**CITY PLANNING COMMISSION AGENDA
OCTOBER 12, 2022**

FILE NO(S):
PUDZ-22-0003 – QUASI-JUDICIAL
PUDC-22-0001 – QUASI-JUDICIAL

PROJECT: INTERQUEST MARKETPLACE

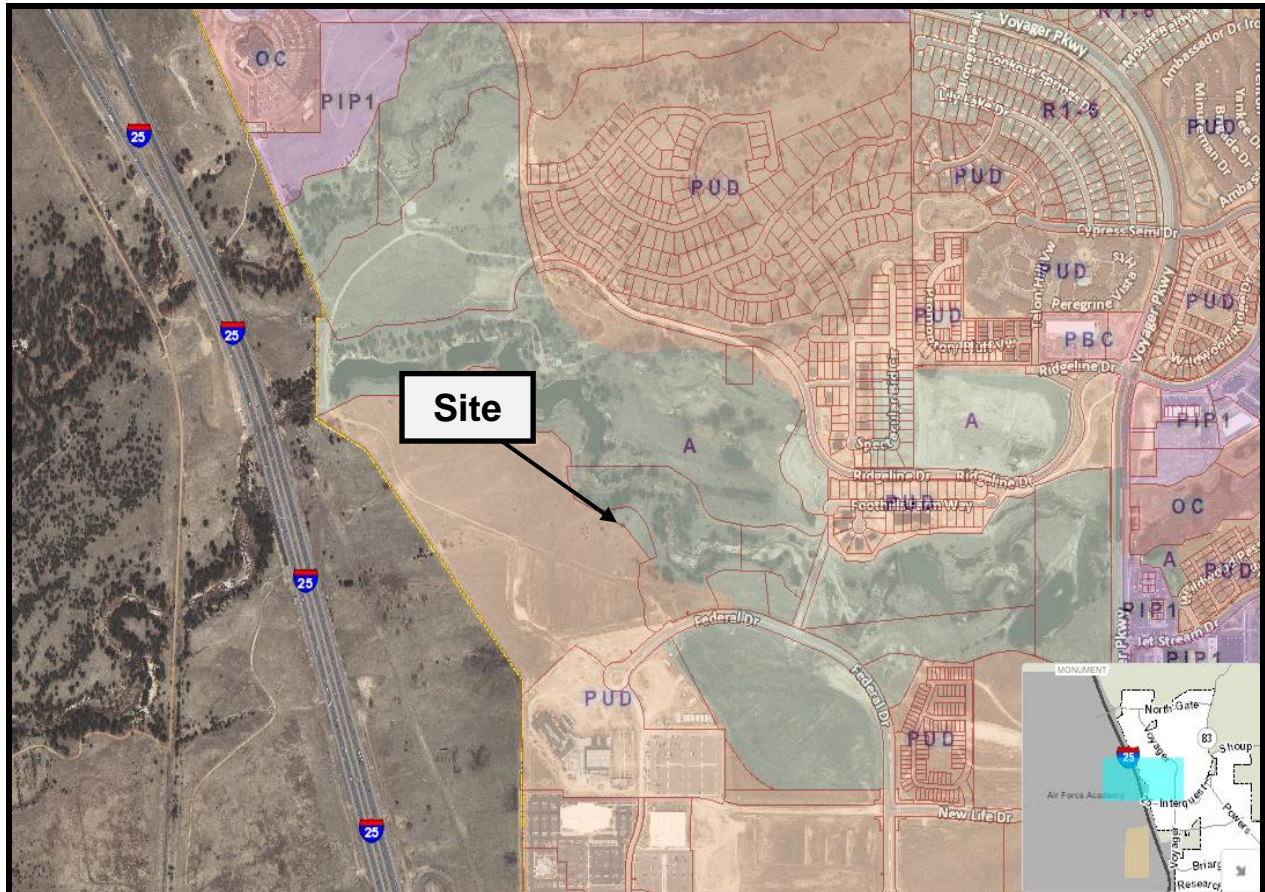
The proposed land use designation for the property is determined by the concept plan (see attached **Concept Plan**). The concept plan does not illustrate the detailed design for this development, and a development plan and final plat will be needed to develop this site. The concept plan will require some technical modifications to be made to the plans to ensure concurrence between the proposed rezoning and approved concept document. First, the concept plan area notes only the 0.35-acre area to be added into the concept plan. As discussed above, this area was previously determined to be encompassed by the PMJM habitat and required additional study by US Army Corps of Engineers. Per that document, no habitat was identified, and the property was deemed developable without restriction. As such, this small area must be included in the concept plan area. Planning staff is requesting a technical modification relating to the project size so that it illustrates the entire 1.6-acre zone change area. The second technical modification relates to the proposed new building height being added as a note to the plans clearly identifying that this project area is subject to the proposed rezoning permitting a 45-foot maximum building height. Staff finds that the requested technical modifications do not materially alter the request but further reinforce the rezoning request.

a. Technical Modifications:

- i. Identify the 1.642-acre area associated with the concurrent PUD rezoning request
- ii. Add note to concept plan acknowledging a maximum building height of 45 feet for the associated 1.642-acre area
